Subject: Capacitor Required with Some Wiegand Readers

Products Affected: **nPort-R1 Single Door Controller**

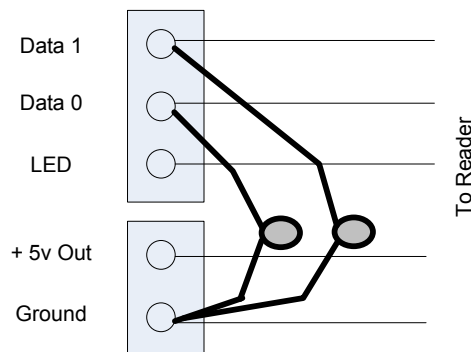
Problem: In certain situations, the card reader signal is not being interpreted correctly by the nPort access controller. The result is an incorrect card number being sent to the system. This can be verified using the Door Status/Access tab in the Inspector Application (version 2.0 of nSecure software).

Example: *Card number 12 was being used at the card reader, but card number 4096 was being displayed at the software.*

How to Fix: Place a **.1uf ceramic capacitor** between reader ground and data 0 input and a second .1uf capacitor between reader ground and data 1 input. This should be done on the blue connector where the reader terminates inside the nPort controller.
